Power Equipment Service Bulletin 2007002

SUBJECT: GX Fuel Cap doesn't Vent When Saturated

Old Style Cap New Style Cap

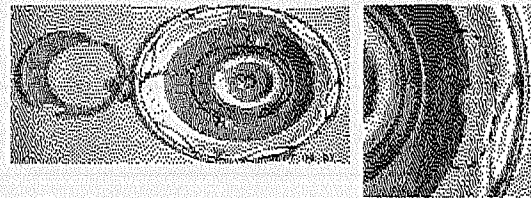
It has come to our attention that some of the new style (low evaporative emission) chromed and carbon canister filled fuel cap, may have the breather blocked.

Blockage may occur if the fuel tank is overfilled and/or the engine is tipped on large angles during loading and/or transportation.

According to our analysis, the cause is a combination of fuel blocking the breather in the new style fuel caps and tight tolerances between the cap outer and the canister.

Please advise your customers to not over fill the fuel tank. There is an insert that is attached to the fuel cap that acts as maximum fill level indicator. This is detailed in the Owner's Manual. Fuel should not be above the lower level of this insert.

There is also a replacement cap available. It can be identified by 2 small dents in the top of the cap or a small notch out of the rubber seal. Part number is 17620-Z4H-010.
